Re: Attachment 5 and Attachment 14 Permit Modification - Notice of Deficiency  
McCommas Bluff Landfill, TCEQ Permit No. 62  
Dallas County, Texas  
Tracking No. 24812634; RN100752146/CN600331730

On behalf of our client, the City of Dallas, please find attached this response to your comment letter addressed to Mr. Dennis Ware, dated December 9, 2019. The attachments with this document completely replace the attachments from the original submittal. Our responses to your comments are presented below in the order received.

**MCCOMMAS BLUFF LANDFILL**  
**APPENDIX 5B**  
**GROUNDWATER MONITORING SYSTEM**

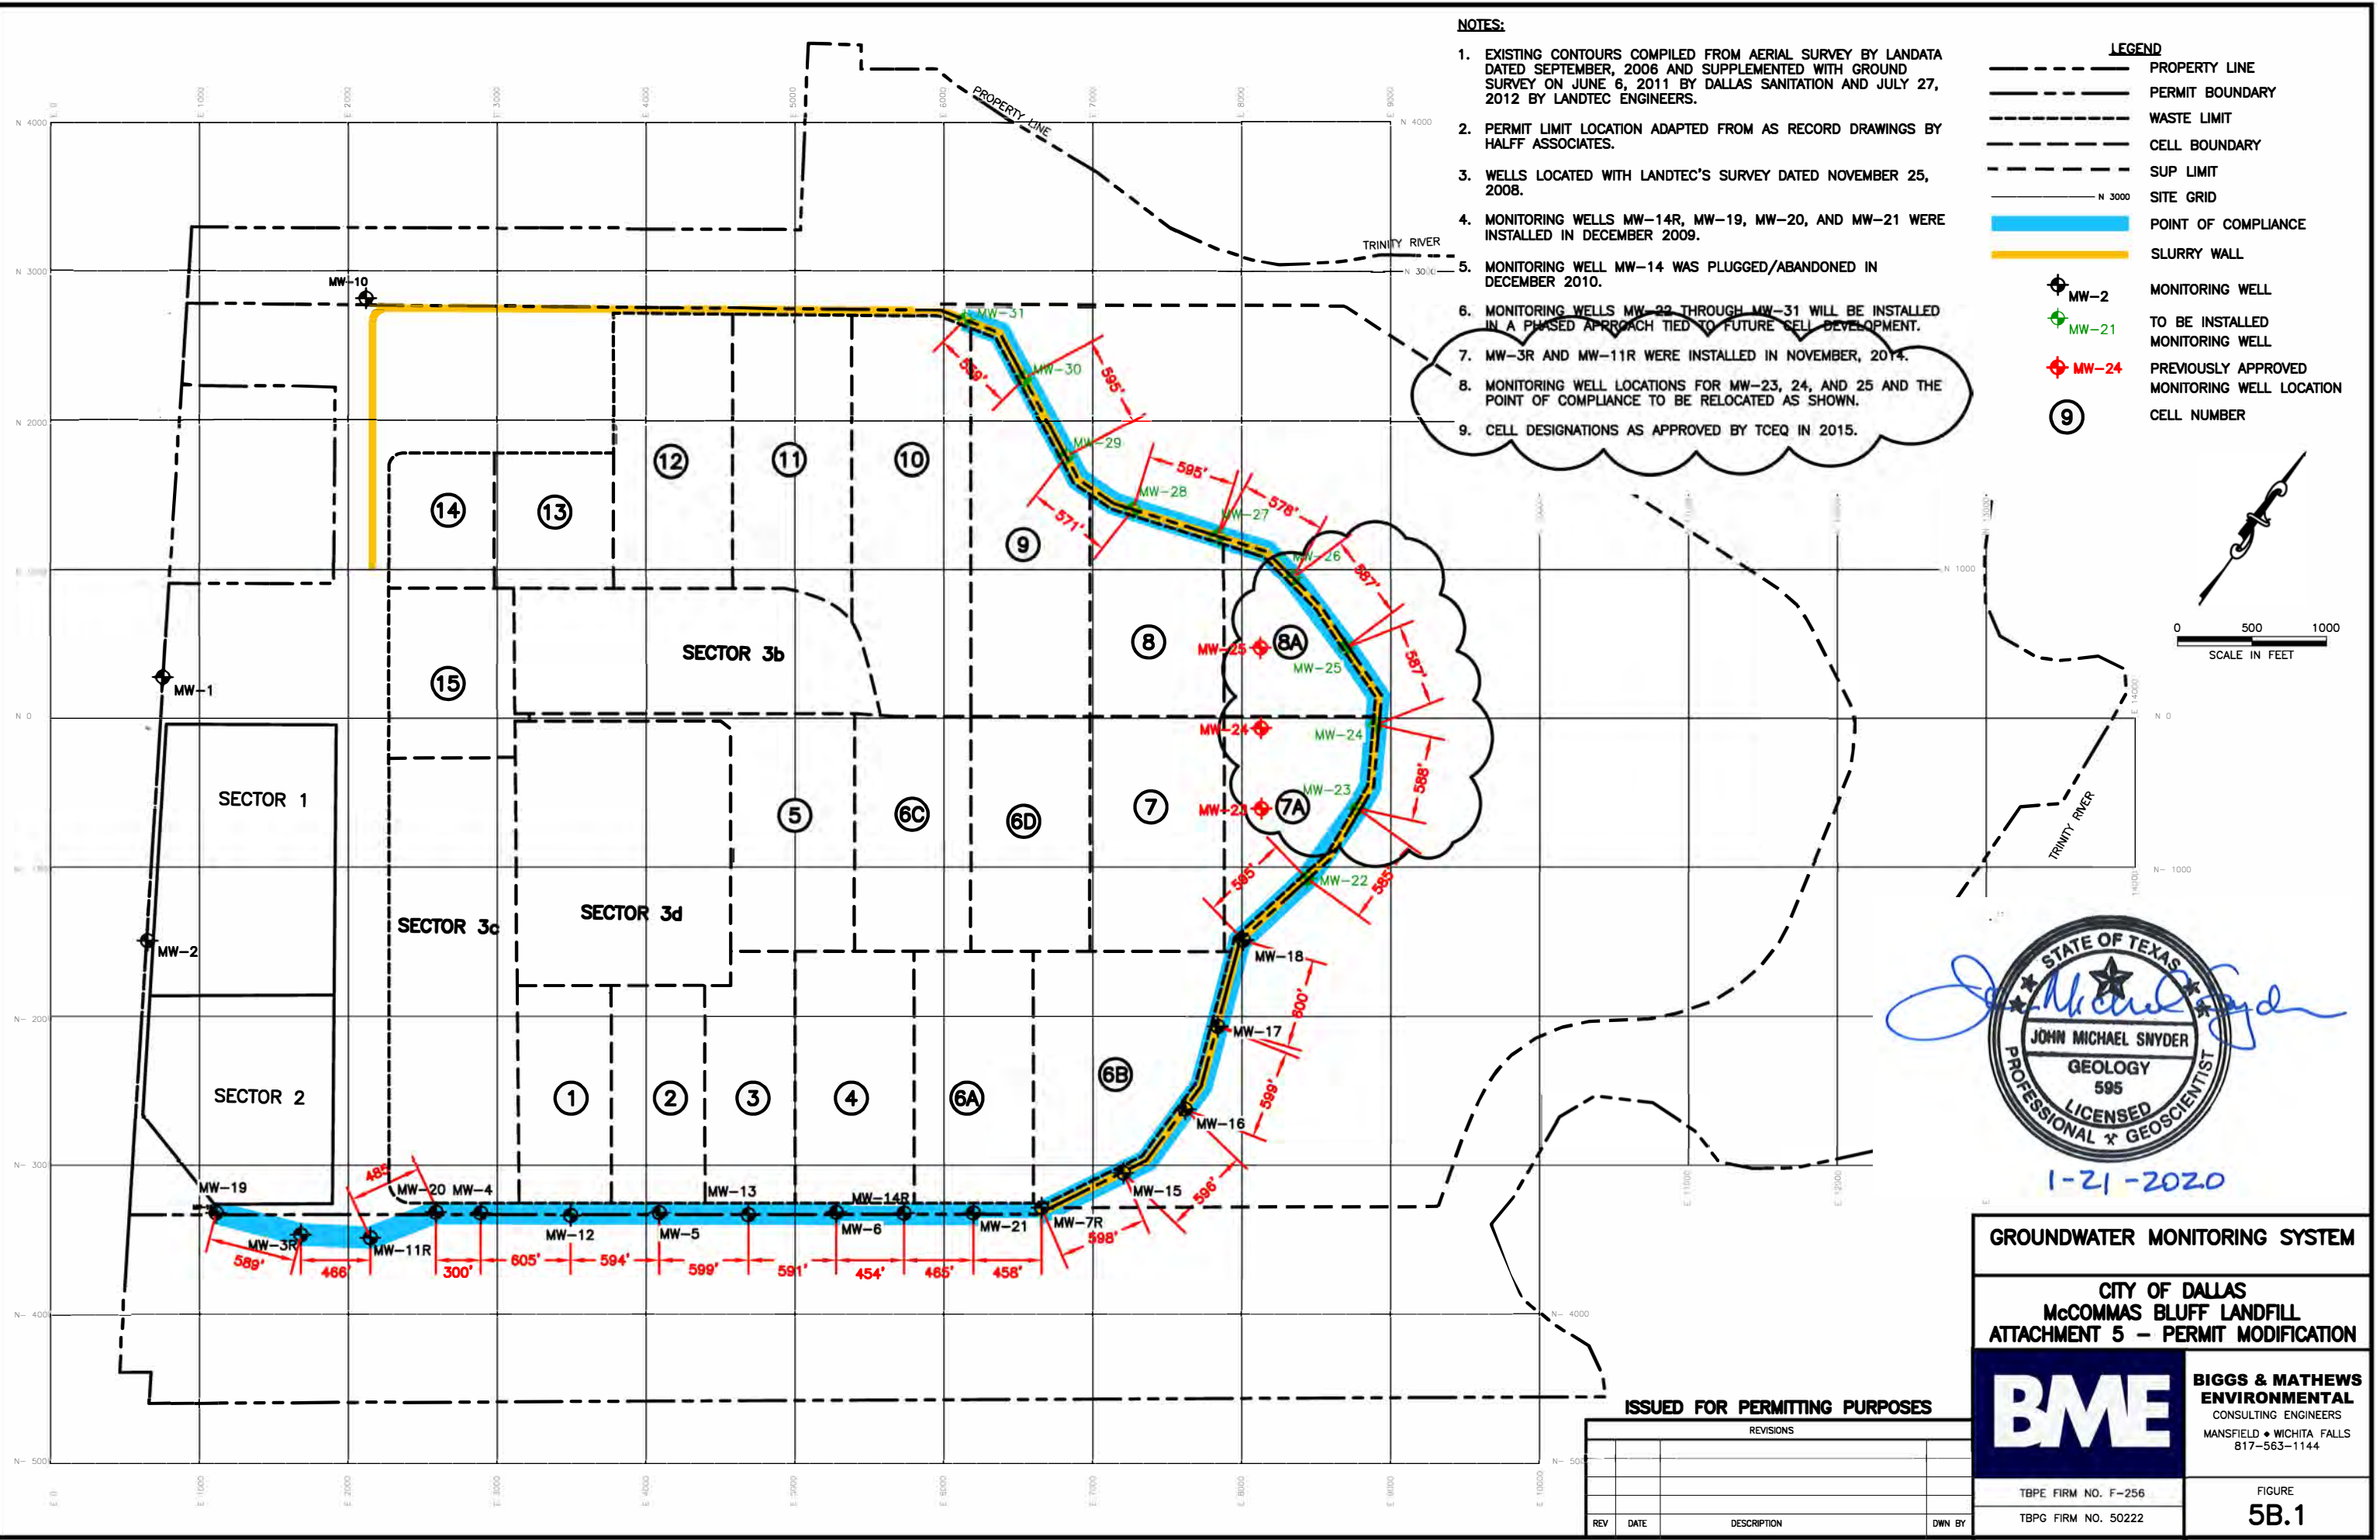
2. Revise Figure 5B.1 in the GCRMP to address the following items:
  - a. Clarify whether wells MW-3R and MW-11R are already installed and revise the symbol on the drawing accordingly.
  - b. Clarify whether well MW-22 has been installed and revise the symbol on the drawing accordingly.
  - c. Confirm the location of the permit boundary on the east side of the landfill and revise the line on the drawing accordingly.

***RESPONSE: a. Monitoring wells 3-R and 11-R have been installed and the symbols on Figure 5B.1 have been revised to reflect that.***

***b. Monitoring well MW-22 has not yet been installed and the symbol on Figure 5B.1 has been revised to reflect that.***

***c. The line designations in the legend on Figure 5B.1 have been revised to properly reflect the permit boundary, the waste footprint, the property line and the SUP line.***

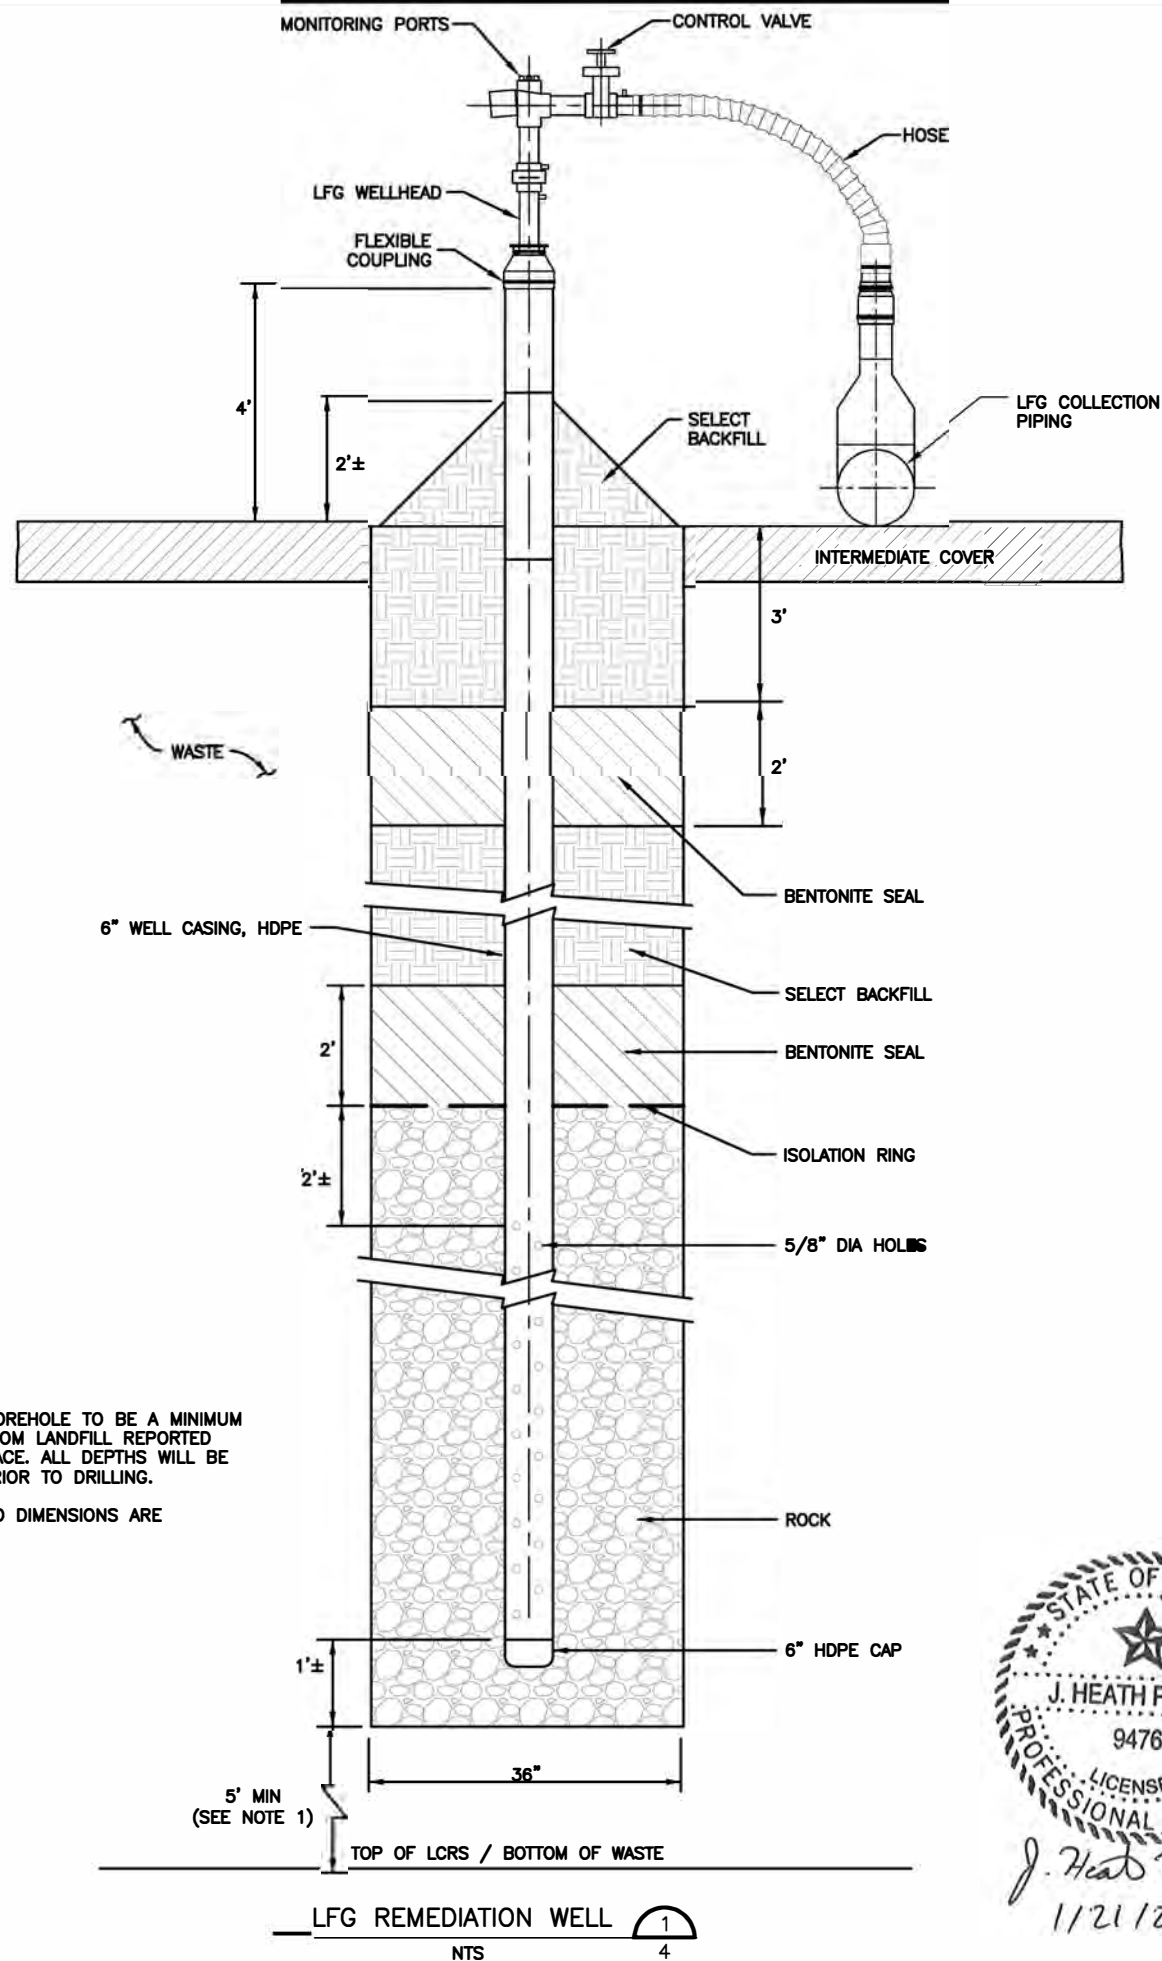
3. Identify the “5 remediation wells,” “6 additional remediation wells,” and “11 existing geoprobes” referenced in the newly added third paragraph in Section 6.0 of the LGMP.

**RESPONSE:** *Additional language has been added to the text to clarify/identify which wells and geoprobes are being referenced.*

LFG REMEDIATION DETAILS

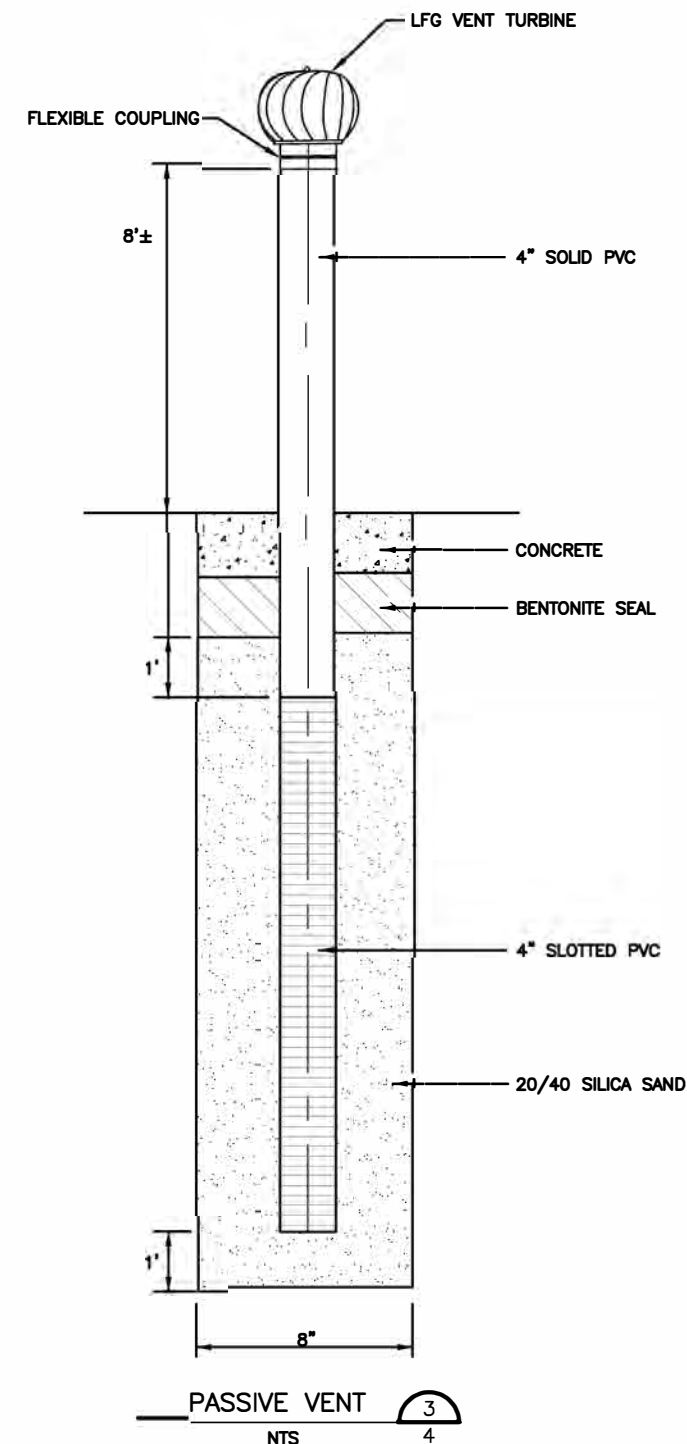
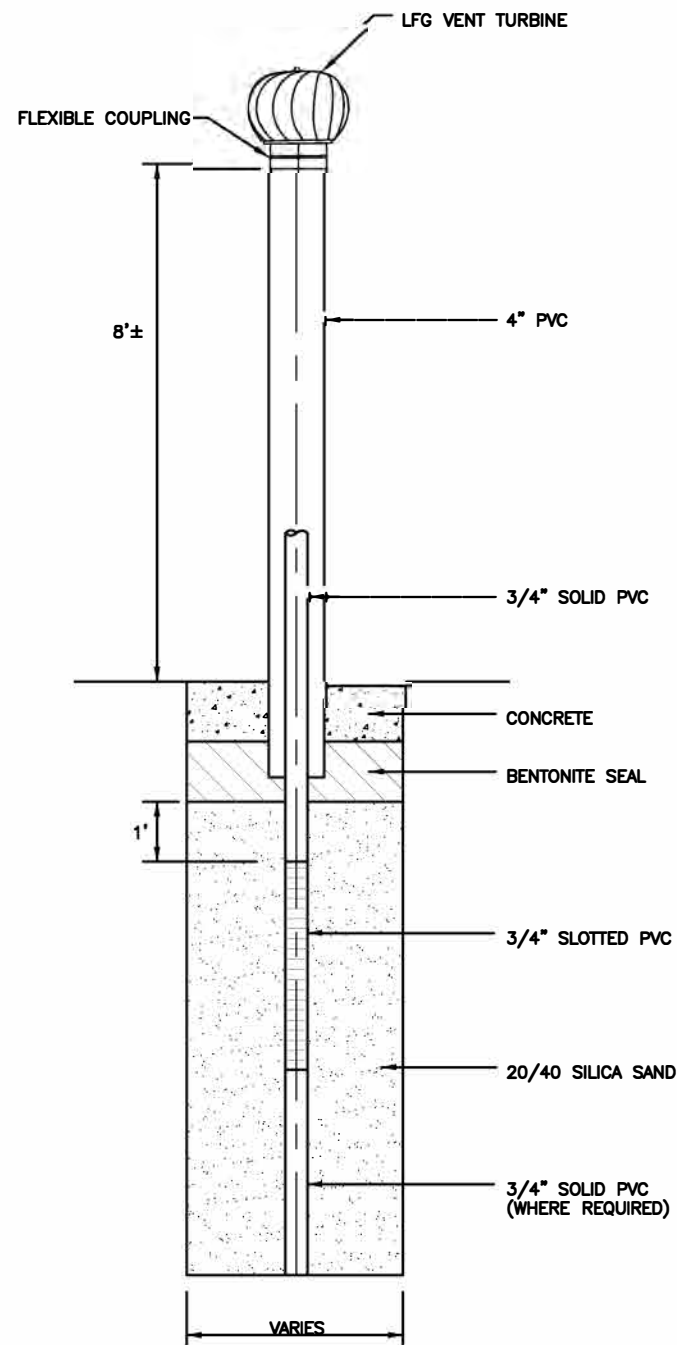
4. Indicate the boring diameter on the second passive vent detail in new Drawing 4.

**RESPONSE:** *The drawing has been updated to show that the passive vents will have an 8-inch boring diameter.*
